**BOARD OF ZONING ADJUSTMENT
STAFF REPORT****Date: April 1, 2013****CASE NUMBER**

5820

1916 Airport Boulevard
(North side of Airport Boulevard, 405'± West of Myrtle Avenue)

PARKING RATIO: Parking Ratio Variance to allow a 3,420 square-foot commercial building with four compliant parking spaces in a B-3, Commercial District.

SITE PLAN

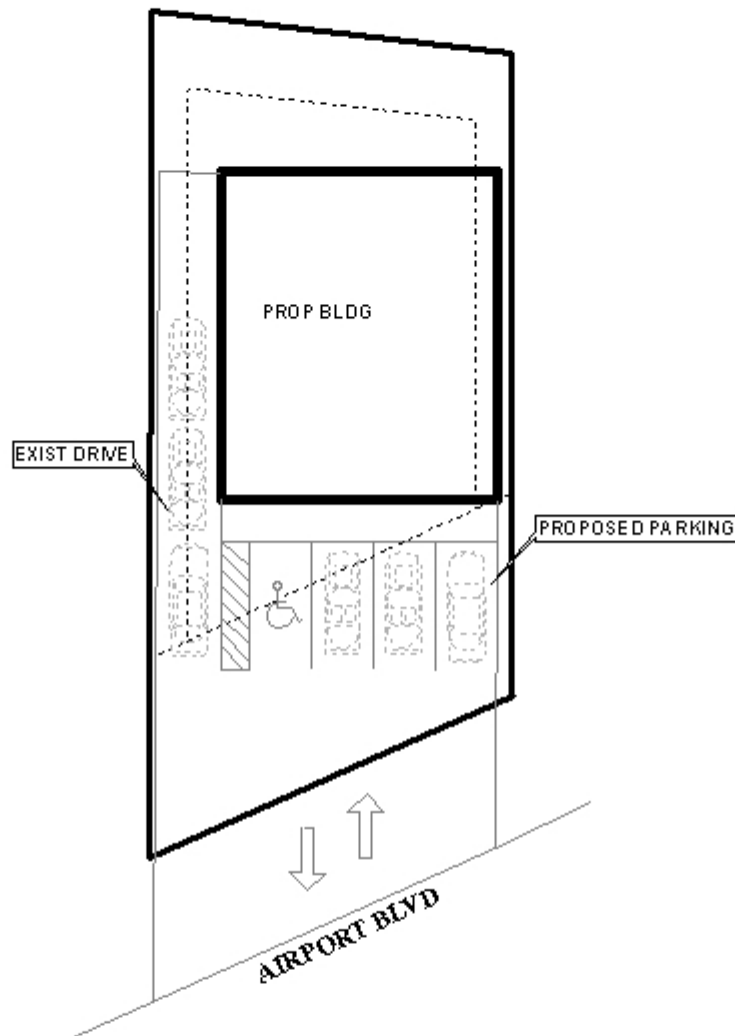
The proposed structure would now meet the 25' minimum front yard setback as opposed to the 18.7' setback of the previous structure which would at least allow vehicles to now be parked completely out of the right-of-way. However, only four compliant parking spaces are indicated, with other spaces stacked in the 9' wide driveway to the rear along the West side of the proposed structure. Aerial photographs indicate this to be the same parking ratio as the previous configuration. And all vehicles would still have to back into the right-of-way to maneuver. Given the increasing volume of traffic along Airport Boulevard in this area, this could cause a potentially dangerous situation. It should be pointed out that the depicted "accessible" parking space must be "van accessible", requiring a striped access area plus parking space width of 16 feet. It appears that the site plan does not comply with van accessible requirements, per building code requirements. However, the site plan submitted does lessen the severity of the previous situation with regard to the reduced maneuvering area.

Although not specified on the site plan submitted, the proposed side yard setbacks seem to be identical to those of the previous structure as shown on the 1994 survey of the site furnished. B-3 districts allow a zero or 5'+ side yard setback off adjacent commercial properties. As only about a 2' setback is proposed on the East side, this would not be compliant with the current requirements. Setbacks less than 5' may require a fire-rated wall, per the adopted building code requirements. A zero setback is allowed with the proper fire-rated wall, or a 5' minimum setback is required in order to allow Fire Department access in case of emergency. As the proposed structure would be placed further to the rear than the previous structure to within approximately 17' of the rear property line, and as a portion of the adjacent residential site to the East (behind the commercial site fronting Airport Boulevard) is within approximately 13' of the rear property line, this would place the Northeast corner of the proposed structure within approximately 4' of the residential property. The intent of the 10' minimum setback off adjacent residential properties is to provide a protection buffer and open space and to lessen visual encroachment. However, with a modification to the Northeast corner of the proposed building, the 10' setback off the adjacent residential site could be met.

With regard to the landscaping and tree planting requirements, the site could potentially provide adequate area to meet those requirements. However, as the rebuild is to be essentially the same size as the original structure, and as the site did not lend itself to satisfying many of those landscaping and tree planting requirements, the downsizing of the proposed building and the drastic reconfiguration of the site would seem harsh. There does appear to be some area in the rear yard to potentially provide a degree of compliance with the landscaping and tree planting requirements, though.

- 1) revision of the site plan to indicate the exact building setbacks off all adjacent properties;

- 2) revision of the Northeast corner of the proposed building to meet a 10' setback off all portions of the adjacent residential property to the East behind the adjacent commercial site on Airport Boulevard;

- 3) revision of the site plan to depict a compliant 'van accessible' parking space and access aisle;
- 4) revision of the site plan to provide as much compliance with the landscaping and tree planting requirements within the rear yard as practicable; to be coordinated with Urban Forestry;

- 7) submission of two (2) copies of a revised site plan to Planning indicating compliance with these conditions.
